Catholic Television Network

**Joint Engineering Exhibit
in Support of Petition for
Partial Reconsideration**

MM Docket 97-217

December 22, 1998

Comparison of Elevation Patterns for Authorized
vs. Proposed ITFS Station WHR-854
(B-Group, Modjeska Peak)

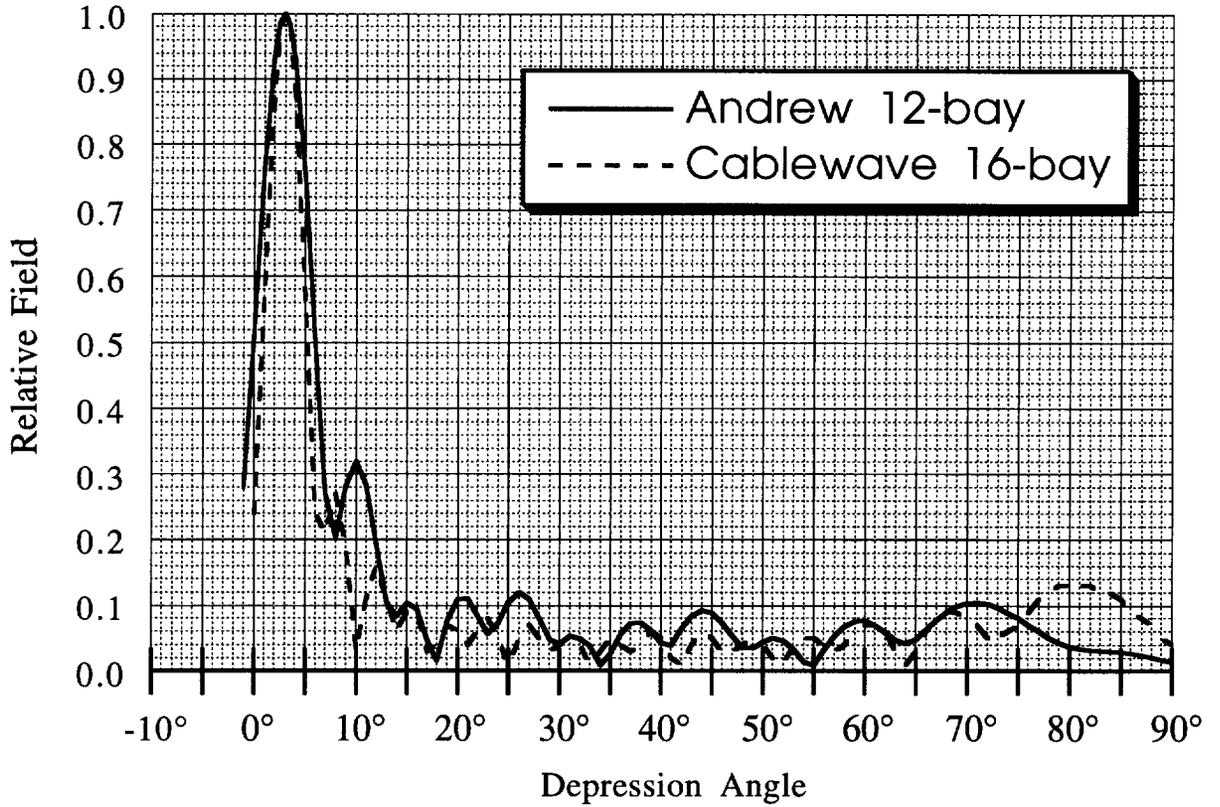
3D. New Rule Section 21.42(c)(8) allows changes to a sectorized antenna system comprising an array of directional antennas to be a permissive change, requiring only after-the-fact notification, if it does not result in an increase in radiated power “in any direction” of more than one decibel. In the past, ITFS Branch staff has indicated that they interpret the “in any direction” term, which currently also appears in Sections 21.23(c)(1)(vi) and 74.911(a)(1), to mean in any horizontal direction, and to ignore changes due to modification of an elevation pattern. This makes no sense technically and can allow much mischief to occur, either by changing electrical or mechanical beam tilts or the number of bays of an antenna. For example, going from a 16-bay antenna to an 8-bay antenna, and then increasing the transmitter power by 3 dB, would result in no increase in the equivalent isotropic radiated power (“EIRP”) based on the azimuth pattern, but could easily make 20 dB or greater changes in the field strength at ground level because the locations of the elevation pattern nulls and side lobes would have shifted. In one case potentially affecting the Archdiocese of Los Angeles, licensee of B-Group ITFS Station WHR-902, Santa Paula, California, just this scenario (*i.e.*, an increase of more than 1.5 dB in the vertical plane, but not the horizontal plane) occurred when California State University Fullerton filed to change its ITFS B-Group Station WHR-854 at Modjeska Peak (one of the Pacific Bell Video Services “master plan” sites) from a Bogner Type B16SS 16-bay antenna with 3° of electrical beam tilt to an Andrew Type HMD12VN 12-bay, still with 3° of electrical beam tilt; as shown by the attached Figure 1, at a depression angle of 10° there is more than a 20 dB difference in the EIRPs. Fortunately, that modification ended up not harming the Archdiocese, but that was just luck; there could have easily have been a fixed receive site, or a hypothetical receive site (*i.e.*, populated areas) at the 10° depression angle. This loophole should be closed, and the Commission should confirm that “in any direction” means just what it says, *i.e.*, that the restriction applies to increasing radiation in the vertical plane as well as the horizontal plane.
